REGULAR MEETING AGENDA

**Tuesday, July 23, 2024
6:30 P.M.**

1. CALL TO ORDER
2. ROLL CALL
3. APPROVAL OF THE MARCH 26, 2024, REGULAR MEETING MINUTES
4. APPROVAL OF AGENDA
5. PUBLIC HEARINGS
 - A. **SPECIAL LAND USE – WHITE WATER CAR WASH – 2675 WASHTENAW AVENUE – PACEL K-11-06-304-004** – TO CONSIDER THE SPECIAL CONDITIONAL USE PERMIT APPLICATION OF EROP, LLC TO PERMIT THE CONSTRUCTION OF A 6,820 SQ. FT. CAR WASH FOR A 1.55-ACRE SITE ZONED RC, REGIONAL CORRIDOR, WITH A PROPOSED SITE TYPE C DESIGNATION.

6. OLD BUSINESS
7. NEW BUSINESS
 - A. **PRELIMINARY SITE PLAN – WHITE WATER CAR WASH – 2675 WASHTENAW AVENUE – PACEL K-11-06-304-004** – TO CONSIDER THE PRELIMINARY SITE PLAN APPLICATION OF EROP, LLC TO PERMIT THE CONSTRUCTION OF A 6,820 SQ. FT. CAR WASH FOR A 1.55-ACRE SITE ZONED RC, REGIONAL CORRIDOR, WITH A PROPOSED SITE TYPE C DESIGNATION.

DRAWING: C-9

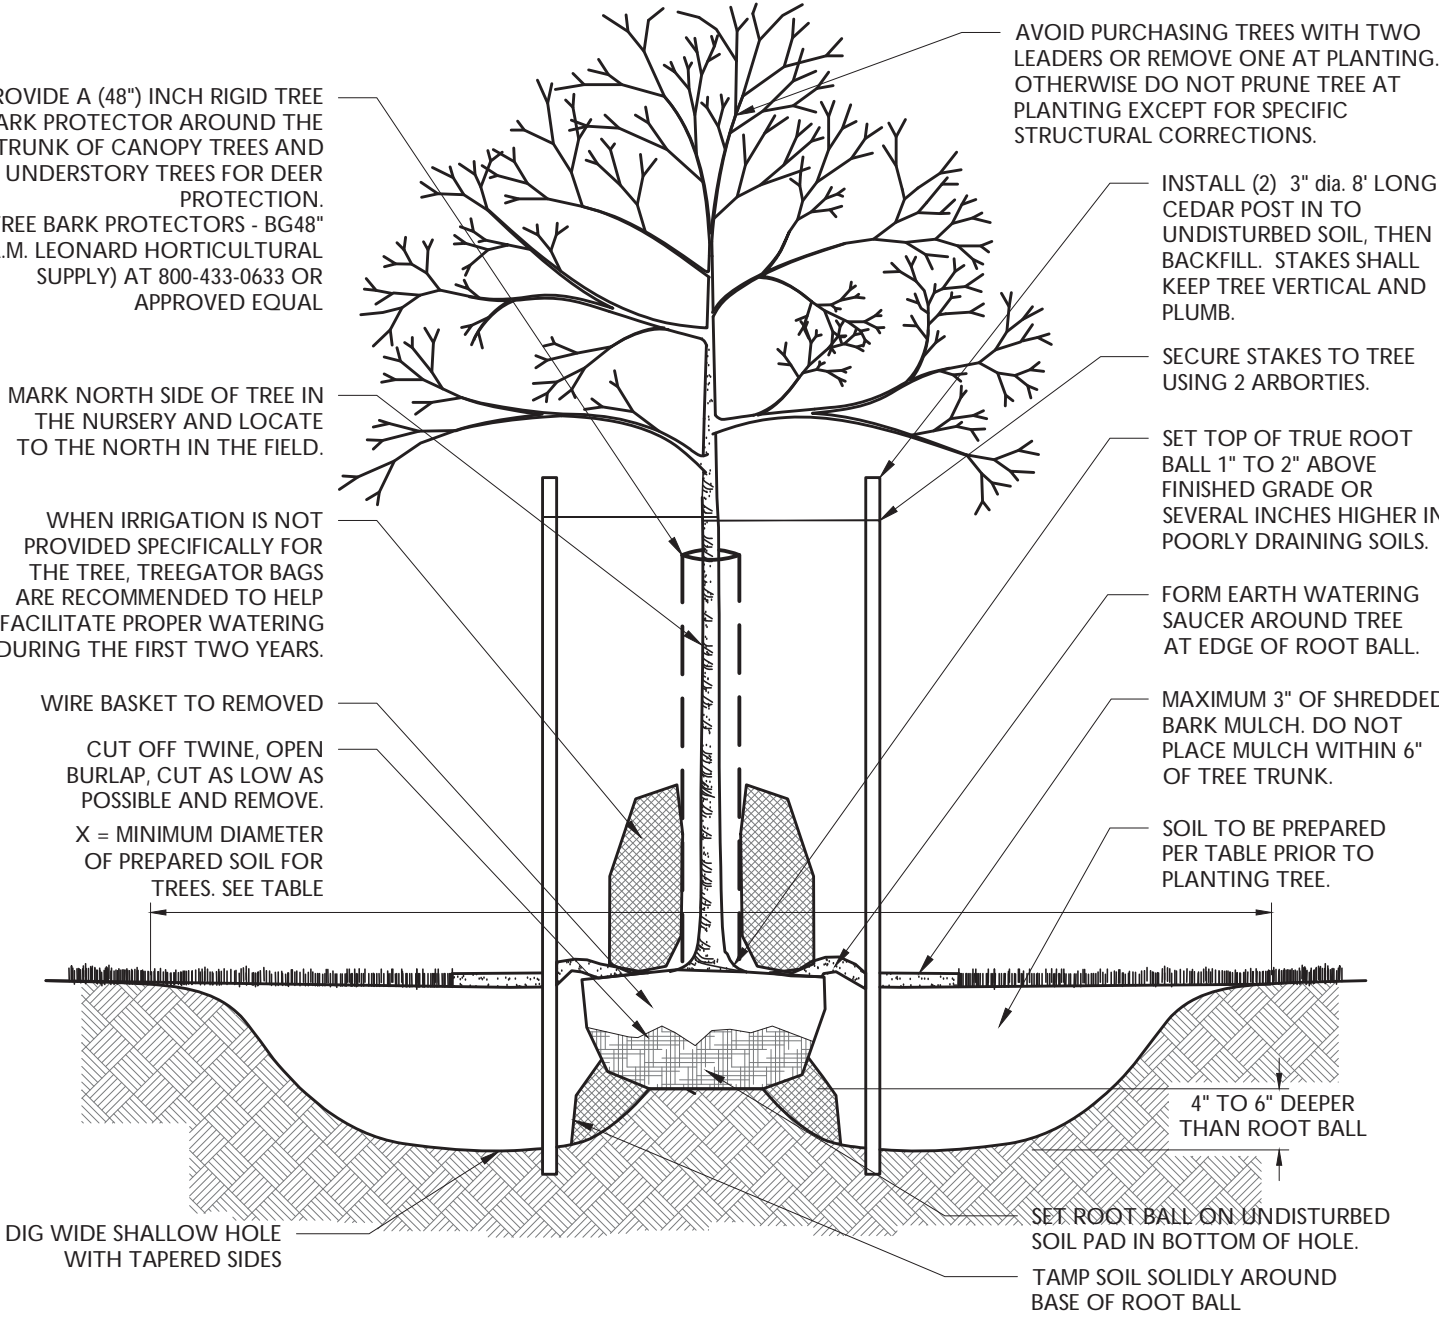
18. A long-term stormwater maintenance plan, including budget and responsible party, should be designed and included with the plan set.
19. The bioretention basin area shown on the landscape plan (sheet C-9) was hatched up to what appeared to be Elevation 793 feet. The hatched area should be expanded to include both the basin and buffer areas.

Stonefield Response: One (1) more general landscaping tree has been added to the Landscaping Plan. See Sheet C-9.

Stonefield Response: Eight (8) more shrubs have been added along Boston Avenue to the Landscaping Plan. See Sheet C-9.

Stonefield Response: Minimum planting sizes have been increased on the Plant Schedule. See Sheet C-9.

Stonefield Response: The proposed tree near the northwest corner of the car wash has been relocated away from the nearby storm sewer. See Sheet C-9.

TRASH / RECYCLE ENCLOSURE DETAIL

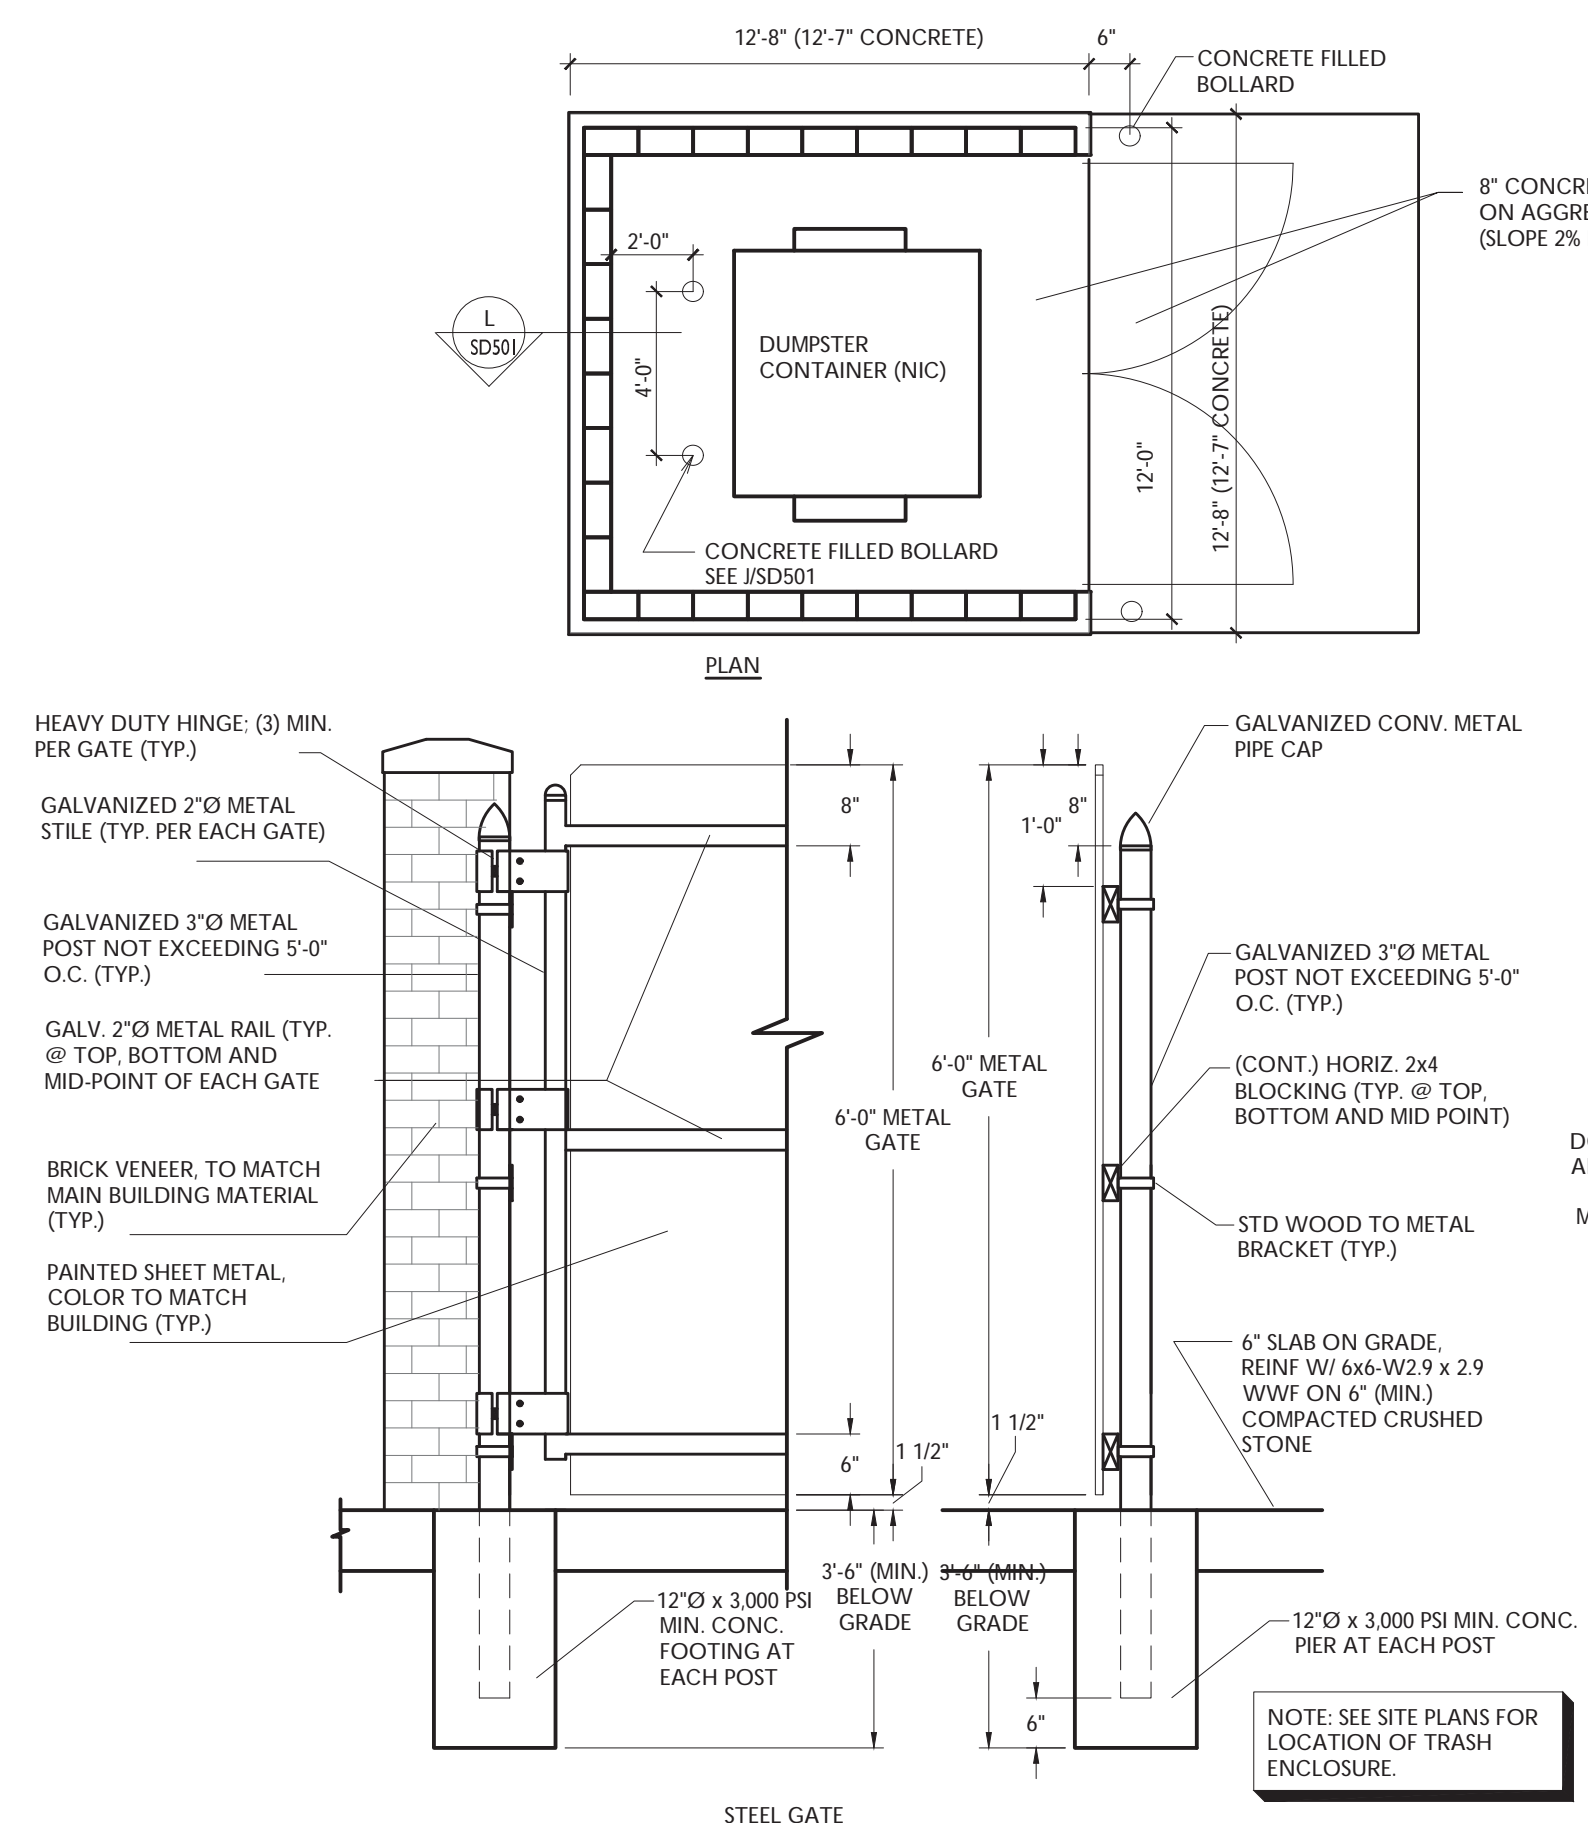
The dumpster screen detail (shown on Sheet C-15) will be a three-sided, 6-foot-tall masonry screen made of CMU block with a brick veneer that matches the building. The gate will be made of metal.
